HISTORIC AND DESIGN REVIEW COMMISSION

Agenda Item No: 14

HDRC CASE NO: 2016-042
ADDRESS: 928 N OLIVE ST
LEGAL DESCRIPTION: NCB 531 BLK 13 W 150 FT OF N 95 FT OF 9 ARB PT A12
ZONING: R5 H
CITY COUNCIL DIST.: 2
DISTRICT: Dignowity Hill Historic District
APPLICANT: Fernando Marin
OWNER: Fernando Marin
TYPE OF WORK: New Porch Railing, Steps and Crawl Space Lattice
REQUEST:

Rendering of Proposed Railing

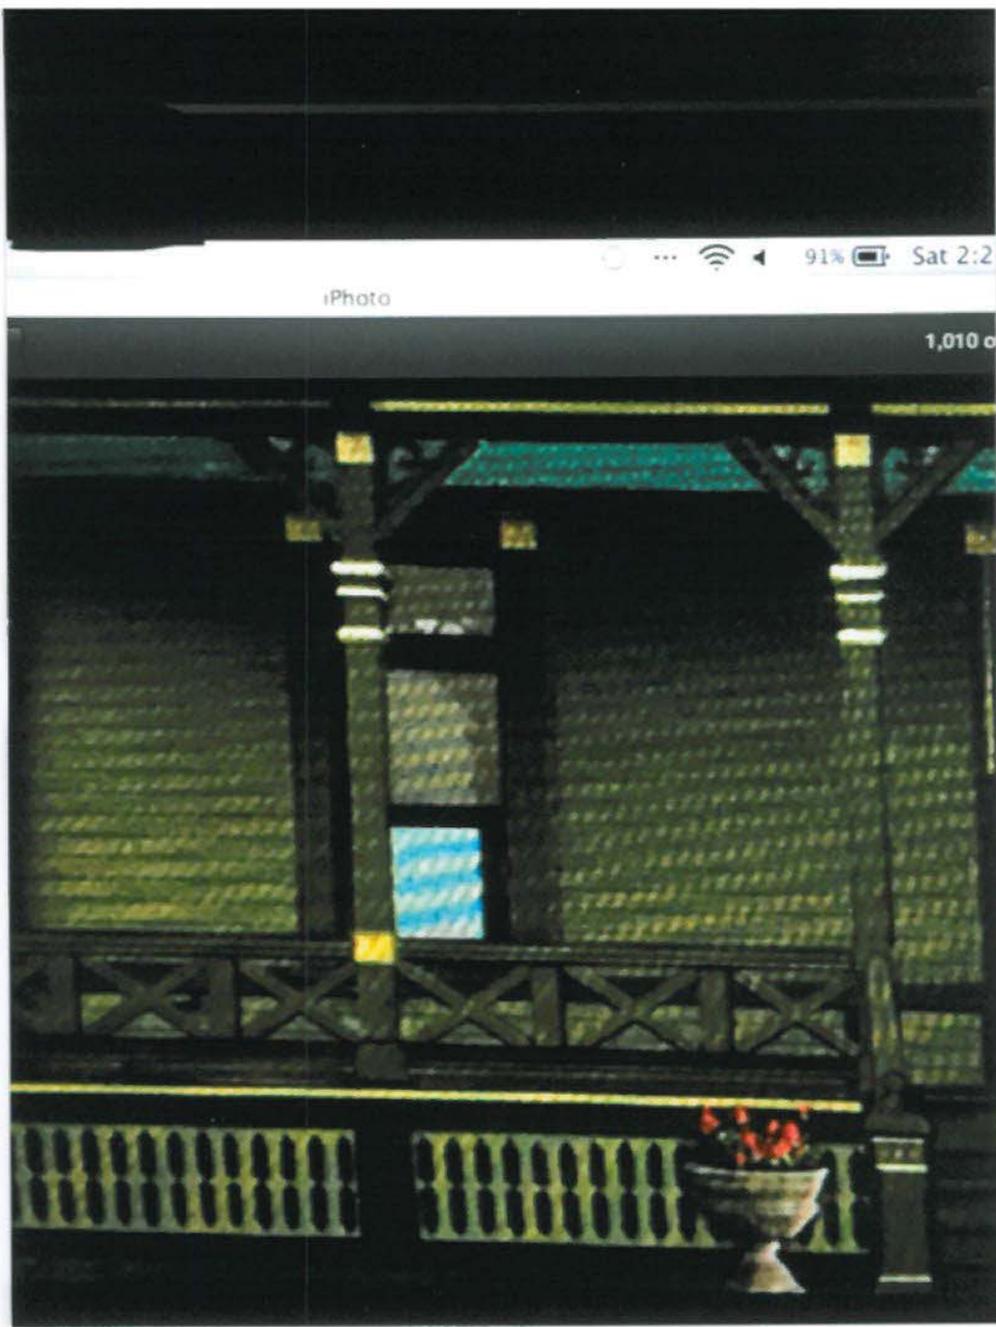
- b. The applicant is proposing to install new wood railings on the north and west sides of the front porch. The proposed style of the railings will feature an “X” brace separated by 8-inch posts. The height will be approximately 27 ½ inches. Each railing will integrate the exiting front porch columns into the design. Photographs found by staff indicate that at one point the house did have front porch railings featuring a spindle pattern.

- e. According to the Guidelines for Exterior Maintenance and Alterations B.iv, replacement elements, such as stairs, should be simple so as to not distract from the historic character of the building. New elements should not be added if they create a false sense of historic appearance. The addition of railings, steps, banister and lattice is consistent with the Guidelines, however staff recommends the applicant install a spindle pattern railing to be consistent with what was originally on the porch.

Staff recommends approval of items 1 through 3 based on findings a through e with the stipulation that the railing design be a spindle pattern.

Close up of Proposed Railing and Lattice Covering

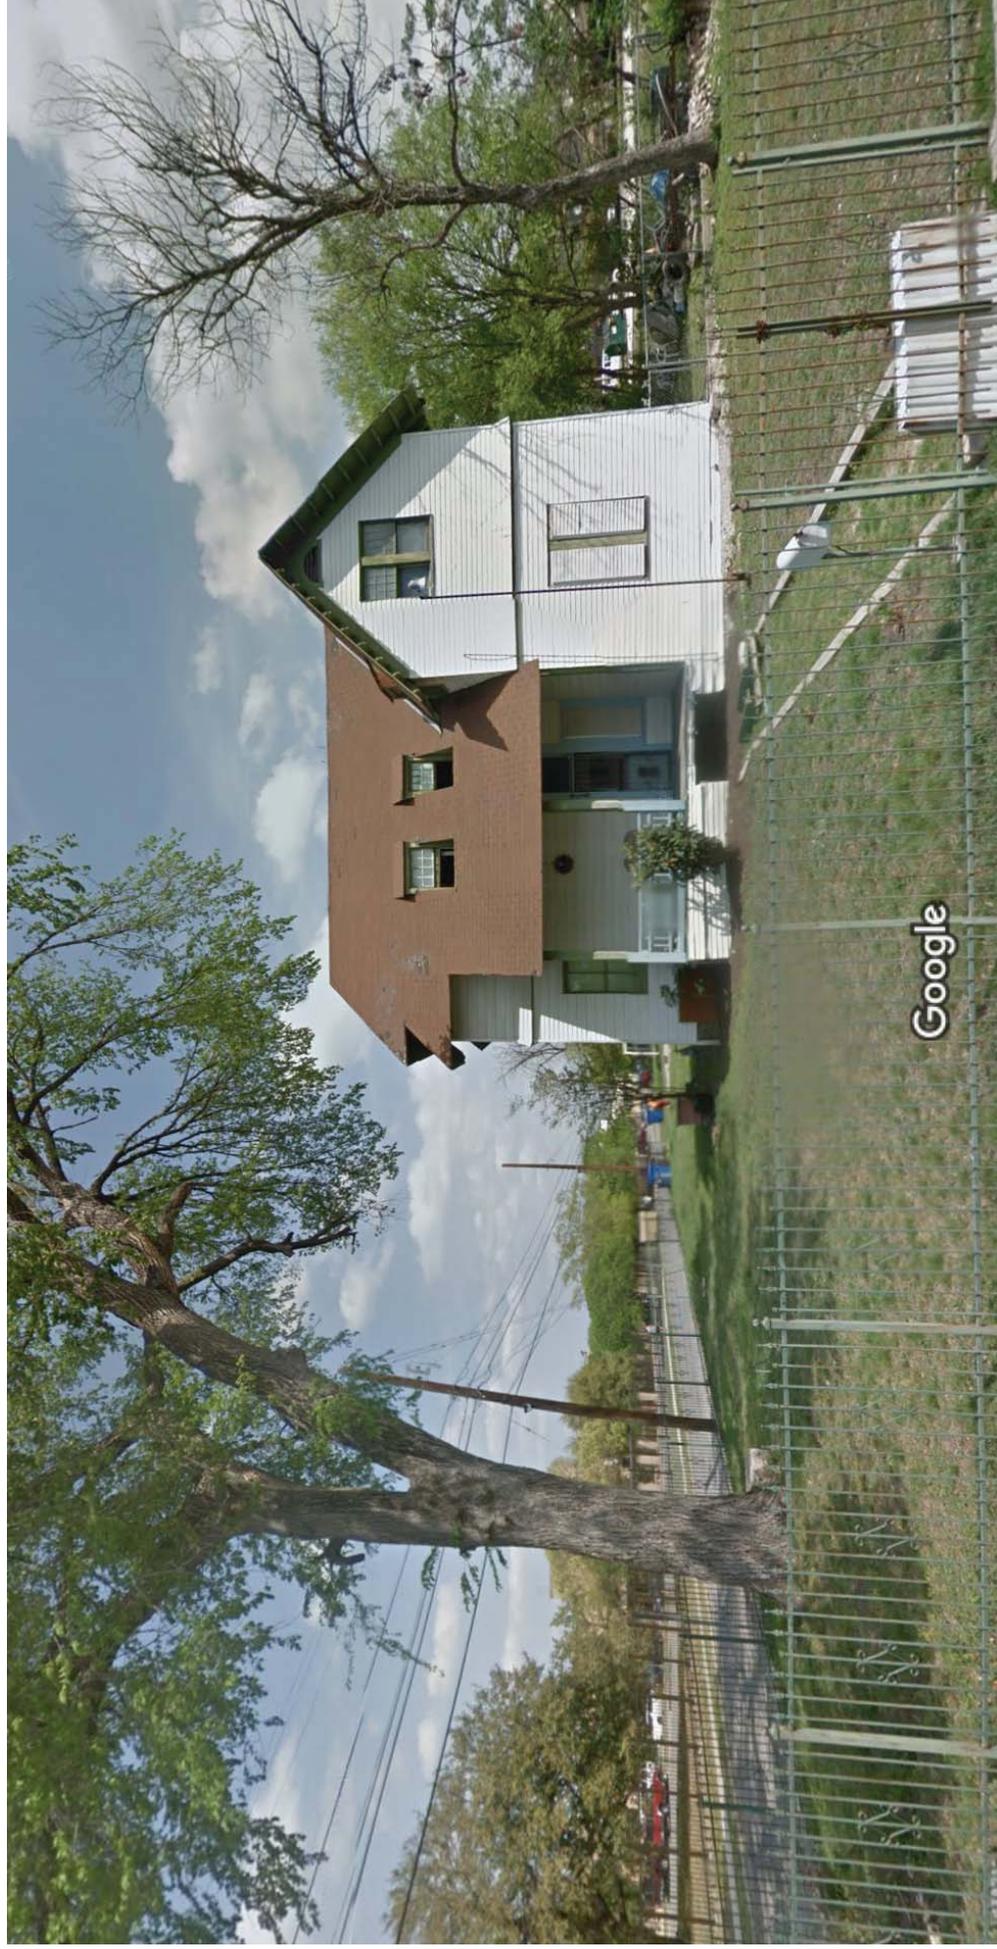
- d. The applicant is proposing to enclose the front crawl space with vertical decorative lattice work. Each lattice slat would be approximately 18-inches high and six inches wide. Lattice is a common feature on pier and beam homes, and provides the house with ventilation.
